A57 LINK ROADS TR010034

**CPRE Peak District and South Yorkshire Branch
Unique Reference: 20029243**

**Response to
REP6-017 - NATIONAL HIGHWAYS' RESPONSE TO SECOND WRITTEN QUESTIONS**

DEADLINE 7 - 23rd March 2022

Figure 5-1 – Trans-Pennine Routing

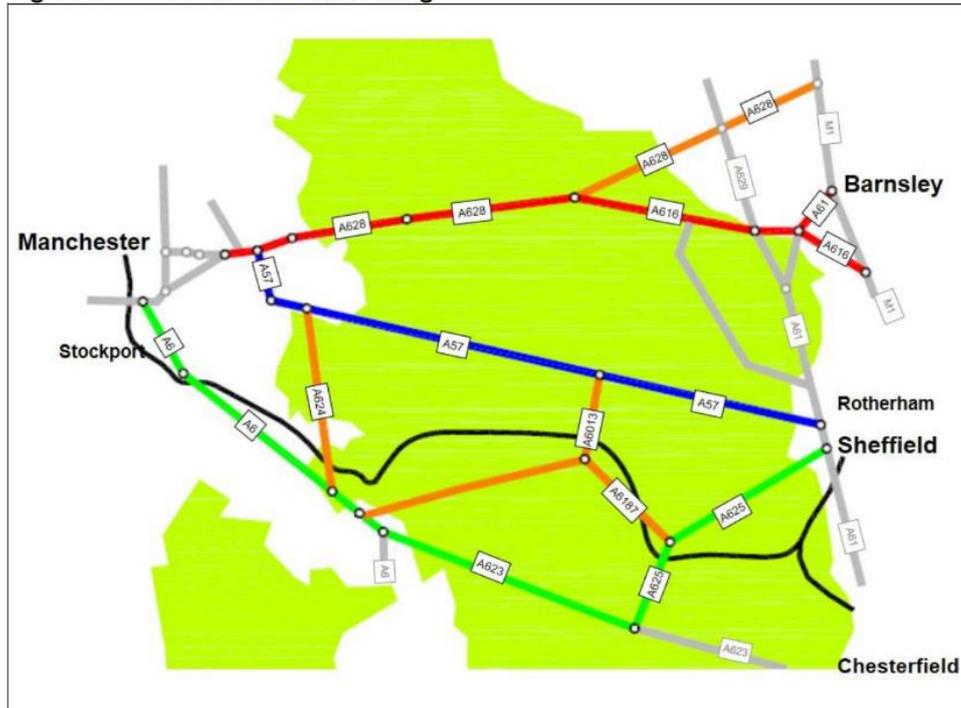
ii. NH has identified within the limits of the modelling that 50-55% of journeys causing increased flows on the Snake Pass would have transferred from the A623/A6 and are journeys between Sheffield and Manchester. However 20-30% of traffic would divert from a variety of routes. What is not clear is how many journeys are rerouting onto the A57 from Chesterfield or further south, to travel to northeast Manchester e.g. to the Trafford centre. These journeys would use the A623/A625/A6187/A6013/A57 and pass through Bamford on the A6013.

iii. The increase on the Snake Pass with scheme is 1,450 AADT. Taking only 20-30% of the diversionary traffic would be 250-435 AADT. NH does not give us the AADT on the A6103 but DfT's CP 57726 shows that manual counts across the previous decade have been between 5,200 and 5,400 AADT (this accords with the figure given in the 2015 Feasibility Study). An increase of 435 is an 8% increase in traffic on the A6103 through Bamford. These flows may appear small but in the village of Bamford they would have a substantial impact, increasing congestion and the risk of road crashes. The diversion of journeys from the southeast would also impact negatively on other villages along the route (using the A619 from Chesterfield the villages would be Baslow, Curbar, Froggatt, Grindleford and Hathersage; from further south other villages would increase this list). The scheme is having widespread and unacceptable impacts on the PDNP which are contrary to its statutory purposes, and should be rejected.
